November 9, 2009

RE: changes to the circuit of Midland Radio Corporation model CB Module FCC ID: MMA77321

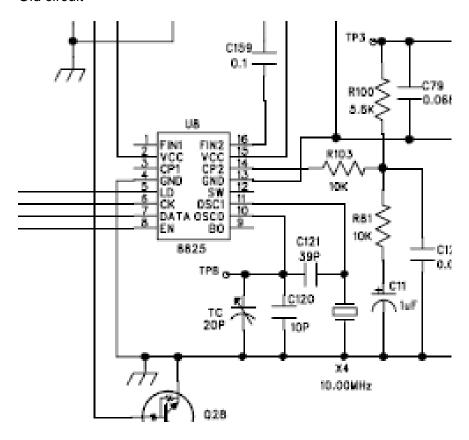
The PLL integrated circuit which determines the operating frequency has been changed due to component availability problem. Only the U8 component in has changed, no PCB layout changes were made.

New circuit

Old circuit

Please accept this as a permissive change.
